Subject ▶ Change on locator

For Models ▶ 6811D/DW (Battery-Powered Drywall Screwdriver) and 6891D/DW (Cordless Drywall Screwdriver)

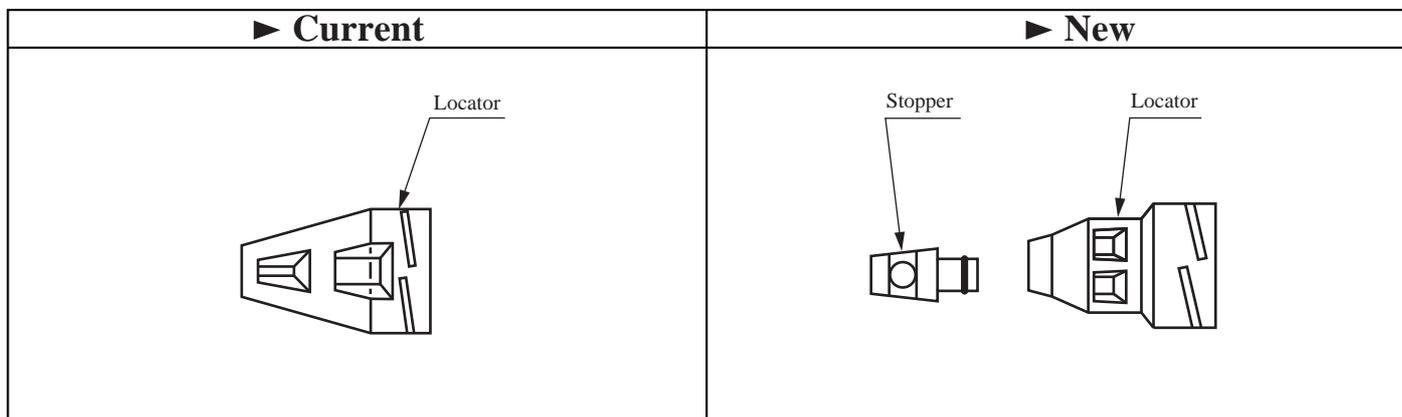
Description ▶ The locator will be changed so that the stopper can be separated from the locator.

The new type locator has the following advantages as the stopper can be separated from it.

1. Screwdriving in tight corners can be performed.
2. Additional tightening and loosening of screws can be performed more easily.
3. The bit can be replaced more easily.

Item No.	Current part		Q'ty	I/C	New part		Q'ty	Note
11	Locator 410908-4		1	No	Locator 415149-7		1	Interchangeable as a set
54					Stopper 152407-7		1
